Log # TXX-95235
File # 916 (5.6)
10010

SUBJECT: COMANCHE PEAK STEAM ELECTRIC STATION (CPSES)
DOCKET NOS. 50-445 AND 50-446
SUPPLEMENTAL RESPONSE TO REQUEST FOR ADDITIONAL
INFORMATION ON LICENSE AMENDMENT REQUEST 94-022,
SPENT FUEL STORAGE CAPACITY INCREASE

RESPONSE TO NRC REQUEST FOR ADDITIONAL INFORMATION (RAI)
REGARDING SPENT FUEL POOL STORAGE INCREASE

Figure 11-1.

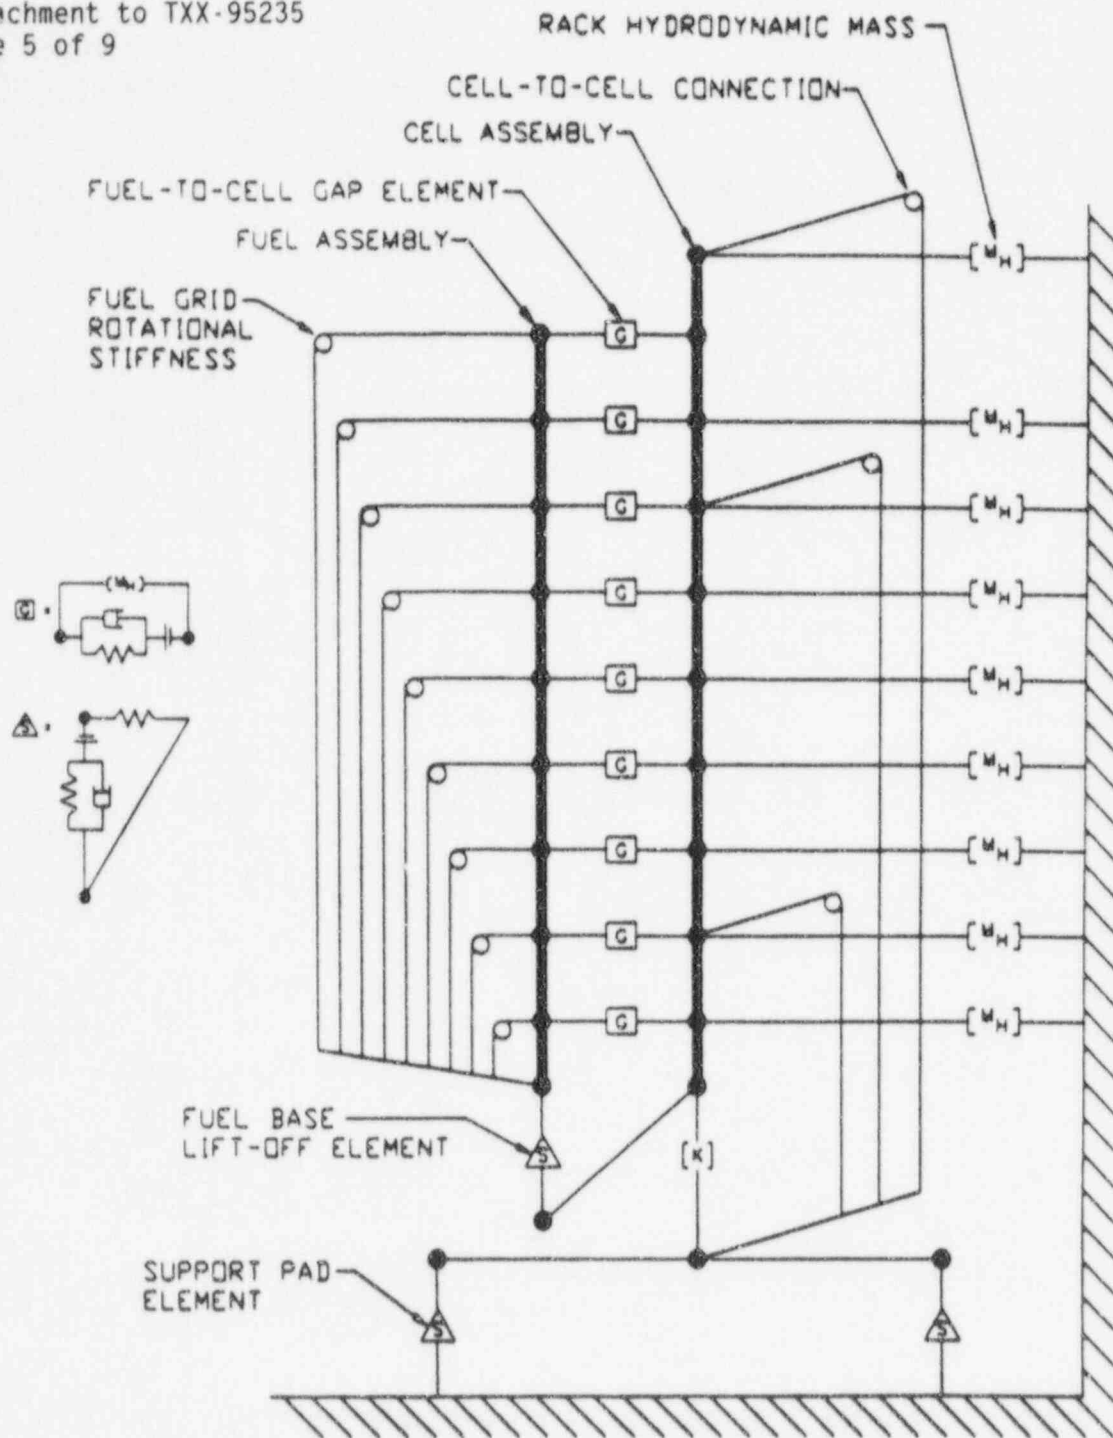
TU Electric indicated that the rack design is controlled by the results of the single rack analysis. Provide justification that the results of a single rack analysis are more conservative than the results of a whole pool multiple rack (WPMR) analysis, or provide comparison of results from a single rack and WPMR results.

In order to perform the WPMR analysis, a reduced element, i.e. reduced degree of freedom (DOF), finite element model for a single rack has been developed. Figure 11-1 shows the full DOF model (2-D view of the 3-D model) used in the single rack analysis, while Figure 11-2 provides the same 2-D view of the 3-D reduced DOF model used to represent an individual rack in the WPMR evaluation. Both models represent the rack in a similar manner, with the elements representing the rack base and support pads being the same in both models. The major difference between the full DOF and reduced DOF

models is a decrease in the number of elements used to represent the cell and fuel beams, the number of fuel to cell impact elements, and the number of elevations at which hydrodynamic fluid coupling mass matrix elements are used.

The reduced DOF model has been qualified by applying both SSE and OBE loadings using the same sets of acceleration time histories as in the full DOF single rack analysis. For both seismic loading conditions, evaluations were made for friction coefficients of 0.8 and 0.2. The results from the evaluation demonstrate that comparable displacements and loads are obtained for the reduced DOF model when compared to those of the full DOF single rack model. It is concluded, therefore, that the use of the reduced DOF model to represent an individual rack in the WPMR analysis is acceptable.
